SI B51 28 18
Body Equipment

GROANING NOISE AT DOOR SILL DURING ENTRY OR EXIT

I12 (i8 Coupe)	I15 (i8 Roadster)
----------------	-------------------

Procedure to repair i8 groaning noise at door sill while entering and exiting

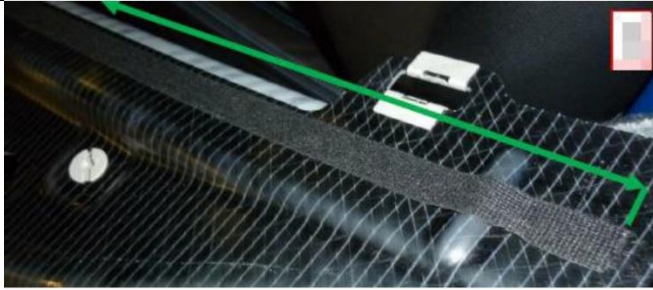
A groaning or creaking noise may be heard when the driver presses against the sill trim (arrows) while supporting themselves as they enter or exit the vehicle. Inspect both sides of the vehicle for noise, and perform this procedure for one or both sides as needed.

1. Carefully remove the sill trim.

- Refer to Repair Instructions 51 47 ...
“Removing and installing/replacing front left or right cover on door sill cover strip”
- Use special tool 00 9 325

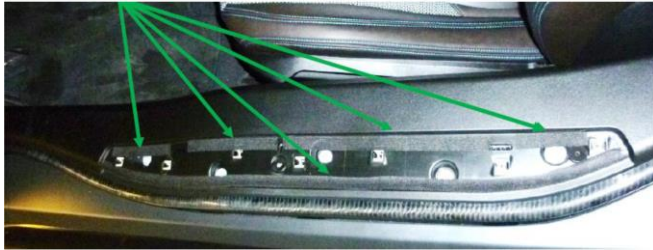
2. Apply a length of self-adhesive felt strip (P/N 54 13 7 181 349) along the sill.

3. Close-up shows how the felt strip goes over the stiffening ribs.

4. Apply various felt strips as shown.
